**SOURCE MATERIALS LICENSE  
SUA-1358, DOCKET No. 40-8681**

**Additional Clarifications to  
White Mesa Mill Reclamation Plan**

**April 15, 1999**

Re: Source Materials License SUA-1358, Docket No. 40-8681  
Additional Clarifications to White Mesa Mill Reclamation Plan

International Uranium (USA) Corporation White Mesa Mill			
Sections D-D' & E-E' from Figure A-5-1 of Reclamation Plan			
DESIGN	BAH	DRAWN	BAH
CHKD BY		DATE	4/2/89
APP		SCALE	as shown

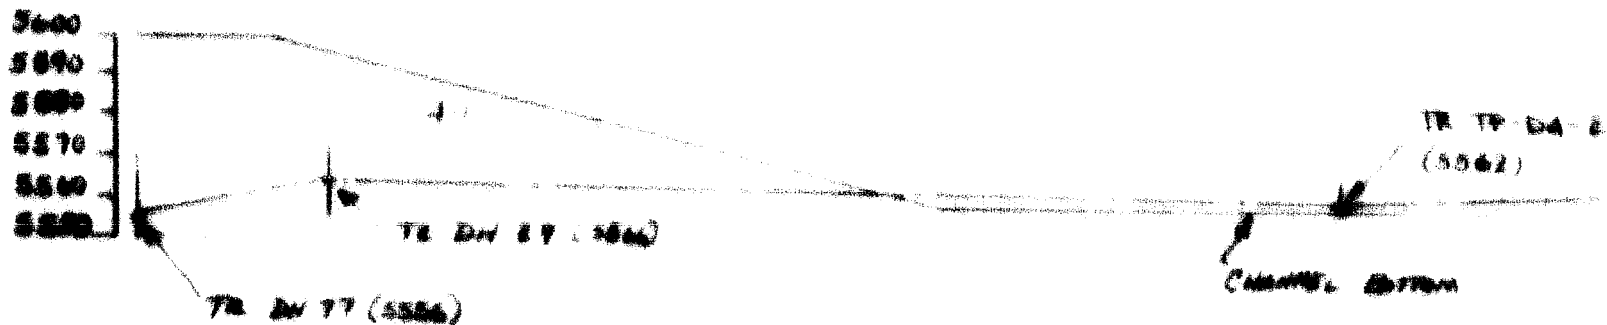
- 4) Sections D and E to Figure A-5.1-1, details the cross sections to the breach of Cell 4A Dike.
- 5) Revised Rational Method Calculation of PMF Peak Discharge, Velocity, Depth, and Scour through Cell 4A Breach, with breach widened to 200 feet.
- 6) Revised details to the Rock Apron at Toe of Cell Outslope. This drawing has been previously submitted to the NRC in response to Question 19 of the August 28, 1998 Submittal to NRC.
- 7) Results of a rerun of the Radon Emanation Calculations to take into account revisions to inconsistent variables and more conservative approach to the assumptions used in cover design, as per NRC staff suggestions,

**RATIONAL METHOD CALCULATION OF PMF PEAK DISCHARGE, VELOCITY, DEPTH AND SCOUR THROUGH CELL 4A BREACH WITH BREACH WIDENED TO 200 FEET IUC WHITE MESA**

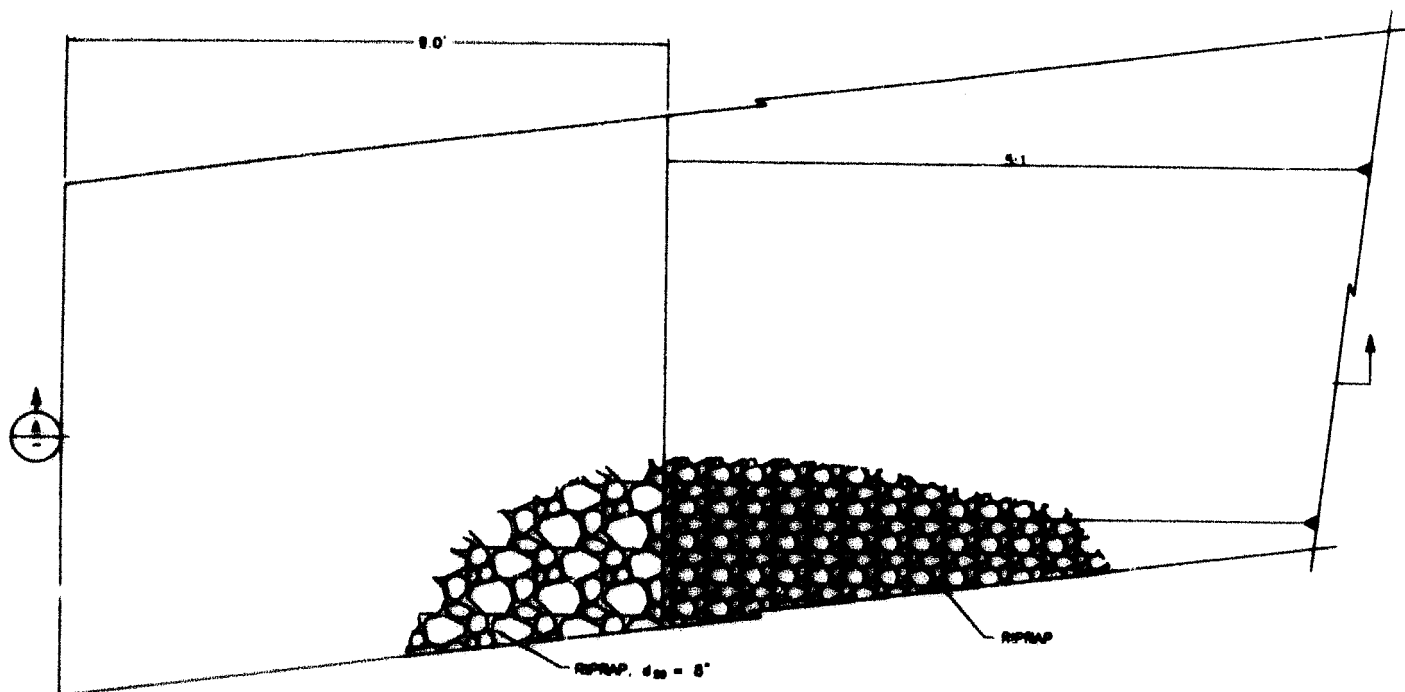
(NOTE: If rounded rock (river cobbles and gravel) is used, rock size should be increased by 33%, per Fig. 4.10, NUREG/CR 4661, Vol. 2

Method 1	ds = K * q <sup>0.24</sup> K = constant 2.45	q =	5.2
		ds =	3.64
Method 2	ds = 0.25 dm dm = mean water depth at design discharge =	ds =	1.4
		ds =	0.36
Method 3	ds = 0.8 * d <sub>50</sub> d <sub>50</sub> = q <sup>0.825</sup> / 1.49 * S <sup>0.333</sup> Flow = zero bed factor = 1.0 ft/s <sup>2</sup> for fine sand	ds =	3.00
		ds =	1.88
Method 4	ds = 0.25 * d <sub>50</sub> d <sub>50</sub> = unit cross section of flow =	ds =	1.38
		ds =	0.38
Method 5	ds = qm <sup>2</sup> / (Vm * Vc)	Vm = mean velocity = Vc =	5.22 2
		ds =	2.19

1.88
